Detailed Site Plan JSF Annapolis Road

DSP-19001

STAFF REPORT

SUBJECT: Detailed Site Plan DSP-19001
 Type 2 Tree Conservation Plan TCP2-034-2019
 JSF Annapolis Road

Figure 2: North Elevation

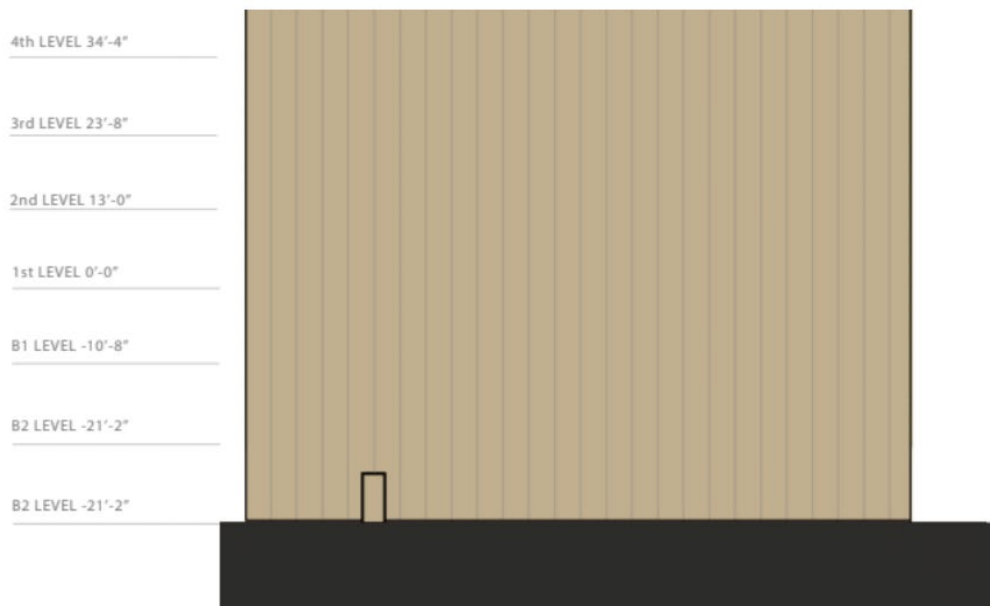
The red split face block continues down a third of the north elevation's ground floor. The north elevation's long mass is broken up by a mixture of tan and gray EIFS columns, three columns of different sized faux EIFS windows surrounded by brick and cementitious siding. In the middle of the north façade is a large section of cementitious siding framing a large square of gray EIFS.

The west elevation is a seven-story-high tan wall composed of EIFS that faces neighboring apartment buildings. There are some vertical joint lines, but no other articulation. The south elevation has strong entrance features with the continuation of glass elements at the southwest corner, red brick surrounding storefront windows, and faux cementitious windows above. The two doors to the storage units on this elevation are surrounded by vertical sections of red brick with tan EIFS inlays and projected roof lines. The south façade, adjacent to the parking lot, highlights the entrance, uses high-quality materials and is broken into a bottom, middle, and top. The east side of this façade, where all seven-stories can be seen, is all tan EIFS with four gray vertical lines.

On page 163 of the Central Annapolis Road Sector Plan and SMA, under the Style and detail D-D-O standard section, it states that low-quality materials, such as EIFS, should be minimized and masked wherever possible. While the proposed architecture does propose EIFS mainly on the rear of the building, there are still large swaths where it is the primary building material and not minimized or masked.

The building elevations were revised to reduce EIFS as the dominate material on the front portion of the building. However, the rear portion requires further reductions in low-quality materials, such that they make up less than 50 percent of each façade in order to be considered minimized. Given that this is one of the first new developments in this area of the Sector Plan, to benefit the development district it is important that the building materials represent a high aesthetic character to establish a precedence. Therefore, staff recommends **disapproval** of this request.

Figure 5: Freestanding and Building-Mounted Signage

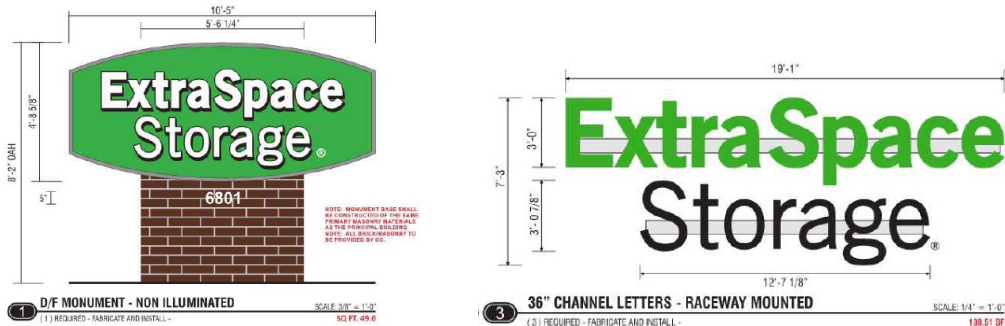
The subject application proposes three building-mounted signs and one freestanding sign. The building-mounted signs will be placed at the top of the building on the north, east, and south elevations. The building-mounted signs will be back-lit, acrylic channel letters mounted on a gray raceway, and 140 square feet each. The freestanding sign will be an aluminum cabinet with vinyl letters, 8 feet tall and 50 square feet. The sign will be placed along the MD 450 frontage on the north side of the vehicular access to the site. The sign will be set on the 3-foot-high red brick base and will not be illuminated. The proposed signage appears appropriate in dimension and style.

The applicant is requesting modification to the building and canopy signs standard to allow internally lit signs on the building. Panelized back lighting and box signs are discouraged. This standard is not mandatory as it is stated as a “should” and not a “shall.” The proposed building-mounted signs are individual letters mounted to a raceway, which is in keeping with the guideline.

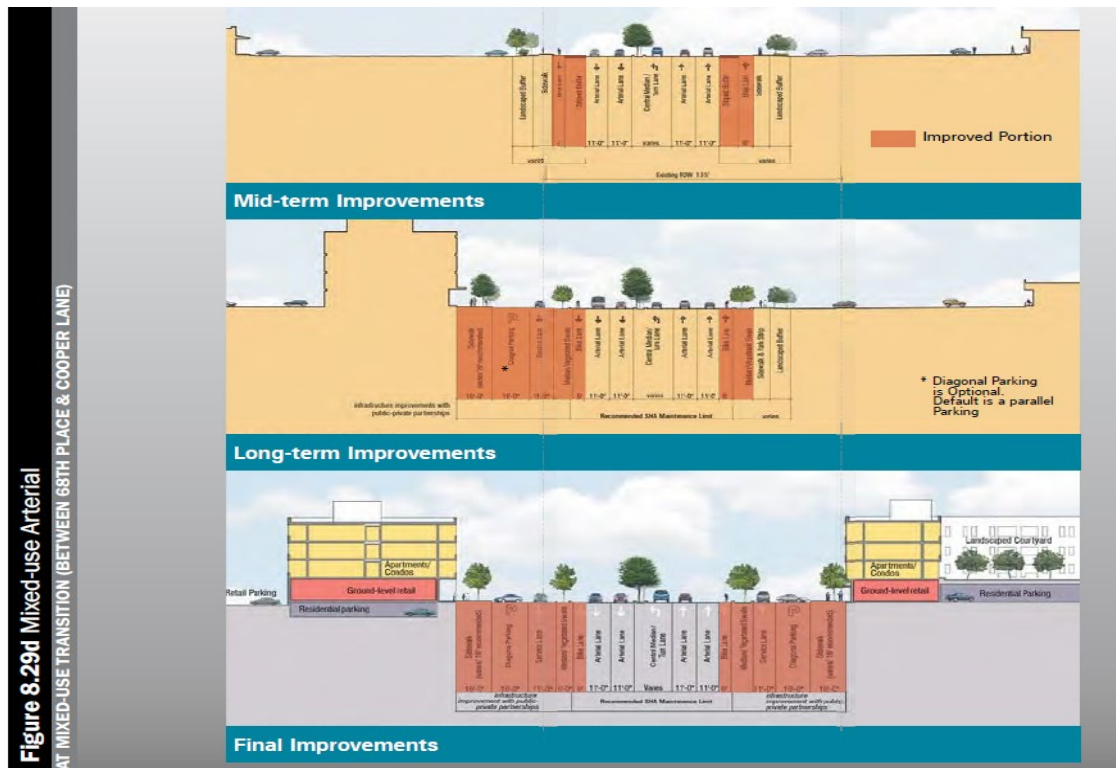
The site is identified within a multiway boulevard section of the Annapolis Road corridor per the Central Annapolis Road Sector Plan and SMA, which includes specific streetscape recommendations that impacts the site's frontage, as illustrated in Figure 8.29d shown below:

The appropriate 120-foot right-of way dedication is shown on the submitted plans. As shown in Figure 8.29d, additional improvements beyond the public right-of-way are planned along the corridor. An exhibit submitted by the applicant demonstrates that the development proposed on the subject site does not preclude the ultimate implementation of the multiway boulevard by the operating agency as proposed in the master plan.
